APPLICATION NO: 2005-167 JURISDICTION: Hamilton County Dist. #9

APPLICANT: Basa Incorporated

HAMILTON COUNTY
CASE NO: 2005-0167
PC MEETING DATE: 9/12/2005
RESIDENTIAL PUD

P.U.D.:	Mountain Lake Estates Planned Unit Development Lots 55 and 89-207
CASE NO.:	2005-167
DEVELOPER:	BASA, Inc.
SURVEYOR:	Copp Engineering Group
DATE OF SUBMITTAL:	August 10, 2005
STATUS:	Preliminary Planned Unit Development Plan
STAFF COMMENT:	1) The property adjacent to the area included in this P.U.D. plan will not be adversely affected. 2) The plan is consistent with the intent and purpose of the Hamilton County Zoning Regulations to promote public health, safety morals and general welfare. 3) The buildings will be used only for single-family, detached dwellings and the usual accessory uses such as garages and storage space and for community activities. 4) There is a need for such development in the proposed location. 5) There is reasonable assurance that development will proceed according to the spirit and letter of the approved plans.

2005-167

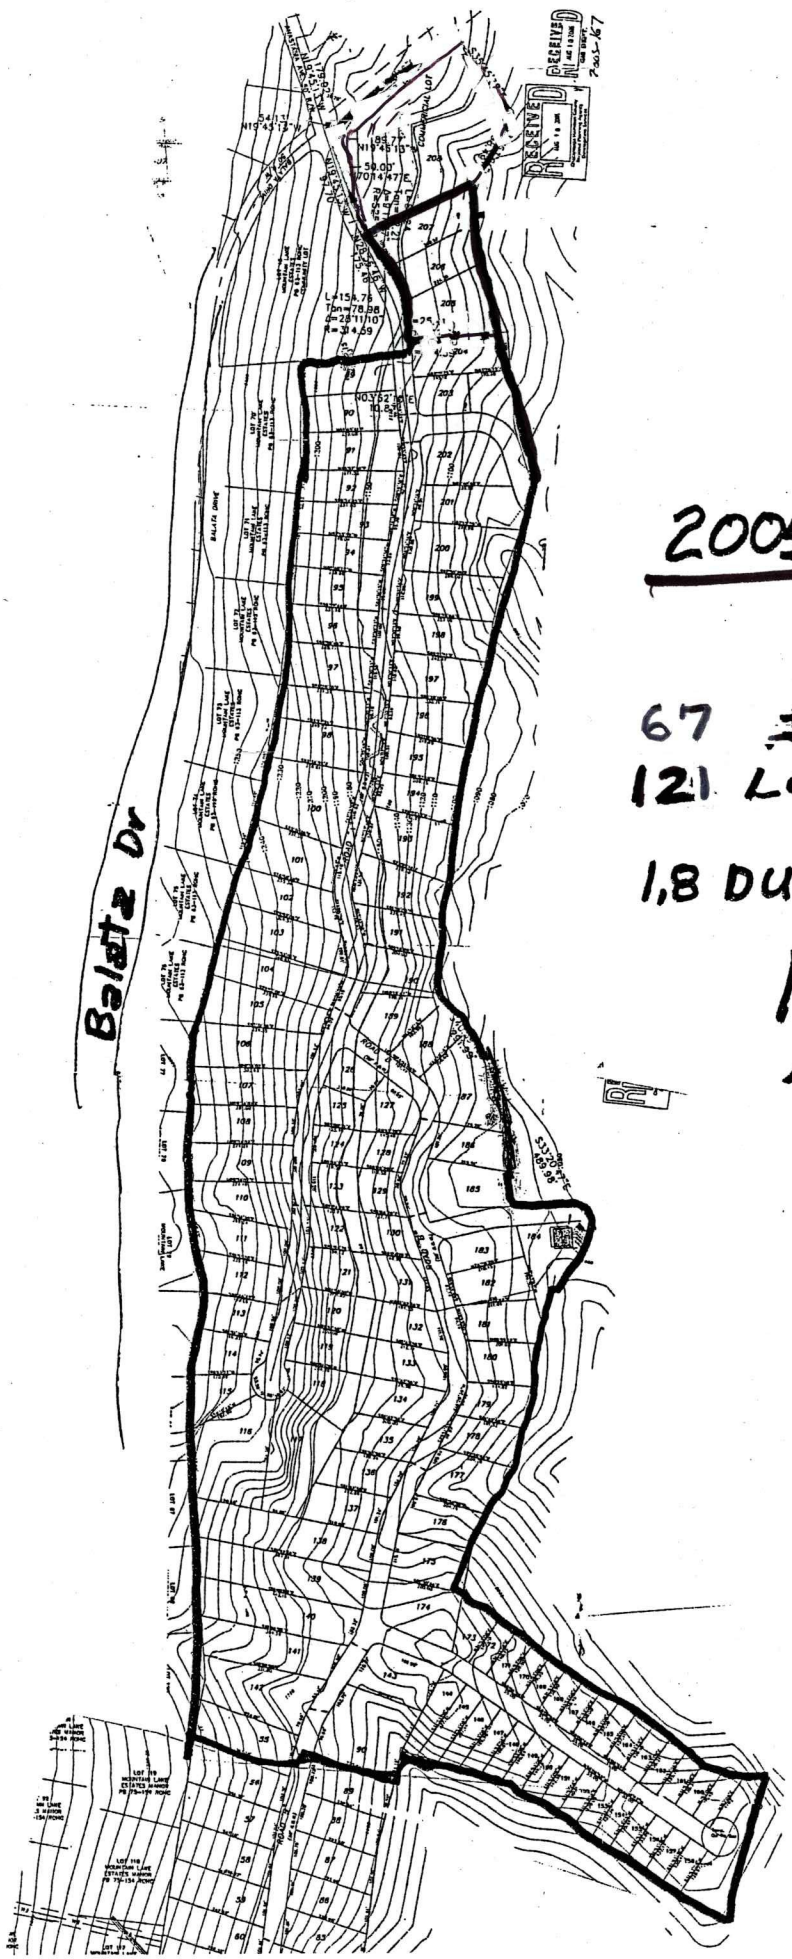
1. Lot numbers 1-129 have already been used in the Mountain lake Estates Planned Unit Development. So that there will be no overlap of lot numbers and to have a logical pattern of lot numbers, renumber all lots starting with lot number 130 and number in a logical pattern.

2. Change the zoning to A-1.

3. Delete note 10.

4. Note that total number of dwelling units and the density of this development.

5. No road profile of the road at lots 143-174 was submitted. Submit a road profile for the road at lots 143-174.

6. Road "A" must be called Anastasia Avenue since it is an extension of that road.

7. Show a 60' radius temporary cul-de-sac at the end of Road "B" near lots 55 and 90.

8. Note that the only minimum building setback required is 25' from the outer boundary of the P.U.D. and 10' between free-standing buildings.

9. Show a 20' sanitary sewer easement where the proposed sewer line is not located in the road right-of-way.

10. Note that the only permitted uses are detached, single-family houses, accessory uses, community uses and sewer facilities.

11. Show the size and number of acres drained for drainage pipes.

12. Drainage pipes will be necessary in the road at lots 143-174. Show the size, location and number of acres drained for these drainage pipes.

13. Add 10' drainage easements at the downstream ends of drainage pipes and spillways.

14. Note that all roads are private and the Government of Hamilton County is not responsible to construct or maintain private roads, drainage easements or drainage detention areas.

15. Submit drainage calculations on the Drainage Calculation Table in Appendix 7 of the Hamilton County Subdivision Regulations for all drainage pipes over 15" diameter.

16. Add a north arrow on sheet 2 of 3.

17. Show on the plat and install a fire hydrant in each of the following locations. Alternative locations are given so that fire hydrants can be installed on the same side of the road as water lines.

a. in lot 203 at the intersection or at the lot line between lots 90 and 91

b. at the lot line between lots 99 and 100 or the lot line between lots 194 and 195

c. at the lot line between lots 108 and 109 or the lot line between lots 123 and 124

d. in lot 185 at the intersection or at the lot line between lots 129 and 130

e. in lots 143 or 174 at the intersection

f. at the east line of lot 159 or the east line of lot 158

18. Since there are more than 25 lots in this subdivision, Section 305.3 of the Hamilton County Subdivision Regulations requires two concrete boundary control monuments located to an accuracy of 1:20,000 in State Plane Coordinates. Show the location and coordinates of these monuments.

1. Submit a geology report for road stability and construction methods.

2. Drainage detention is required. Submit a drainage plan including a drainage detention plan.

3. Submit pre- and post-development drainage calculations.

4. Construction of roads on side slopes will have to be done in such a way as to prevent sliding downhill.

5. Rough grade the roads prior to final P.U.D. plan submittal.

6. A minimum 8" of crushed stone base is required on roads.

1. Add a 10' power and communication easement along both sides of all new roads except in lot 48 per Plat Book 63, Page 113.
